UNITED STATES PATENT AND TRADEMARK OFFICE

APPLICATION NO.	FILING DATE	FIRST NAMED INVENTOR	ATTORNEY DOCKET NO.	CONFIRMATION NO.
10/527,251	03/09/2005	Jean Taylor	31132.339	2831

Office Action Summary

DETAILED ACTION

Figure 1

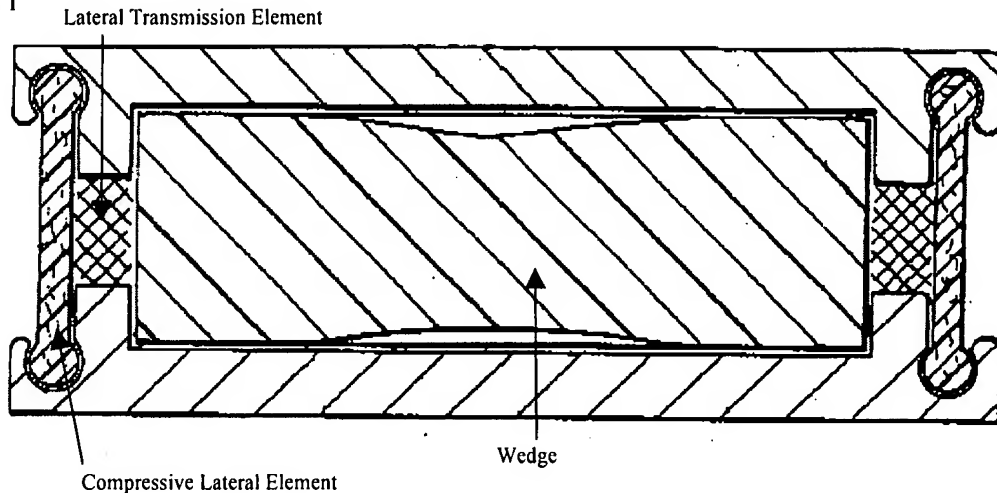
6. Claims 14-18 are rejected under 35 U.S.C. 102(e) as being anticipated by Eberlein (U.S. Publication 2003/0045940).

Regarding claim 14, Eberlein discloses a device that is capable of being placed between and in contact with the spinous processes of two vertebrae comprising an elastically deformable wedge wherein the deformable zone is the entire wedge, two compressive lateral elements, and two lateral transmission elements (see Figure 1 below). The compressive lateral elements are disposed on either side of the wedge in a longitudinal direction and are capable of being deformed between releasing and compressive positions. The lateral transmission elements are disposed between the wedge and the compressive lateral elements and are capable of pressing against the wedge in the transverse direction. Regarding claim 15, Eberlein discloses a device wherein the wedge has a limit of compressibility in the transverse direction and is capable of reaching that limit at a predetermined tilted position. Regarding claim 16, Eberlein discloses a device wherein the compressive lateral elements have a limit of deformation in the transverse direction and is capable of reaching that limit at a predetermined tilted position. Regarding claim 17, Eberlein discloses a device wherein the compressive lateral elements are elastically deformable between the releasing and compressive positions. Regarding claim 18, Eberlein discloses a device wherein the compressive lateral elements are elastically deformable along an axis of the spine.

Figure 2

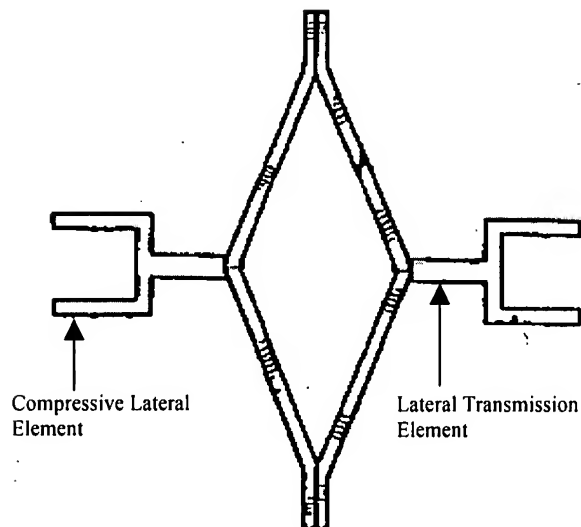
8. Claims 14-22, 24, 26, 27, and 34 are rejected as understood under 35 U.S.C. 103(a) as being unpatentable over Elberg (U.S. 6,440,169) in view of Samani (U.S. 5,645,599).

Regarding claim 14, Elberg discloses a device capable of being placed between and in contact with the spinous process of two vertebra comprising two compressive lateral elements and two lateral transmission elements (see Figure 2 below). The compressive lateral elements are disposed on either side of the wedge in a longitudinal direction wherein the compressive lateral elements are deformable between releasing positions and compressive positions. The two lateral transmission elements disposed

between the compressive lateral elements and the wedge and are capable of pressing against the wedge in the transverse direction. Regarding claims 17 and 18, Elberg discloses a device wherein the compressive lateral elements are elastically deformable between the releasing and compressive position and wherein the compressive lateral elements are elastically deformable generally along an axis of the spine (column 4, lines 52-53). Regarding claim 19, Elberg discloses a device wherein the compressive lateral elements are independent of one another and wherein each element is capable of being connected to a vertebra with one end and to another vertebra at the other end.

Regarding claim 26, the combination of Elberg and Samani disclose a device wherein the compressive lateral elements are capable of being deformable between releasing positions wherein they are relatively spaced apart from the wedge and compressive positions wherein they are relatively close to the wedge in a transverse direction. Regarding claim 27, the combination of Elberg and Samani disclose a device wherein the two lateral transmission elements are capable of being disposed in a manner to press against the wedge in the transverse direction when the compressive lateral elements are displaced in the compressive position. Regarding claim 34, the combination of Elberg and Samani disclose a device wherein the compressive lateral elements are capable of being deformed between a releasing position and a compressive position, wherein in the releasing position the compressive lateral elements are disposed relatively close to the wedge in a transverse direction and in the compressive direction the compressive lateral elements are disposed relatively spaced apart from the wedge in a transverse direction.

Figure 3

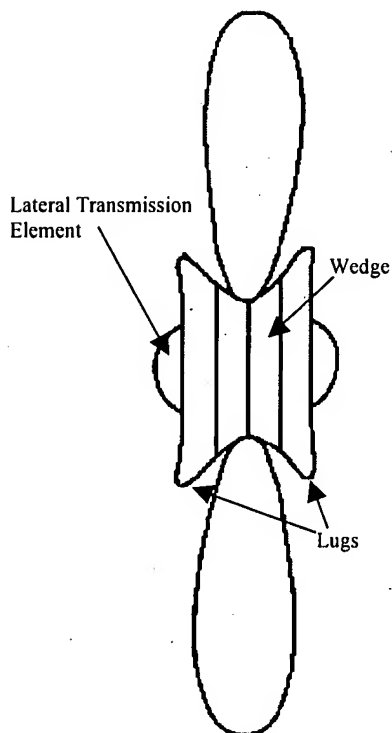
9. Claims 28, 30-33 are rejected under 35 U.S.C. 103(a) as being unpatentable over Zucherman (U.S. Patent 6,514,256) in view of Howland (U.S. Patent 5,496,318).

Regarding claim 28, Zucherman discloses a device comprising an elastically deformable interspinous wedge, wherein the zone of deformation is the entire wedge, capable of being inserted between the spinous processes of two vertebrae and first and second lateral transmission elements capable of pressing against the wedge in a transverse direction in response to forces applied to the first and second compressive lateral elements (see Figure 3 below). Regarding claim 30, Zucherman discloses a device wherein the first and second lateral transmission elements are bosses.

Regarding claim 31, Zucherman discloses a device wherein the bosses are integral with the wedge. Regarding claim 32, Zucherman discloses a device wherein the wedge includes recesses capable of receiving the bosses. Regarding claim 33, Zucherman discloses a device wherein the wedge comprises two curved recesses bound by two

lugs capable of broadly enveloping the spinous processes. Zucherman fails to disclose the device further comprising a circular strap capable of being placed around at least two spinous processes and the wedge. Howland teaches a device comprising a strap capable of being placed around at least two spinous processes and a wedge in order to hold the device in place (column 4 lines 58-67). It would have been obvious to one having ordinary skill in the art at the time the invention was made to manufacture the device of Zucherman further comprising a strap capable of being placed around at least two spinous processes and a wedge in view of Howland in order to hold the device in place.
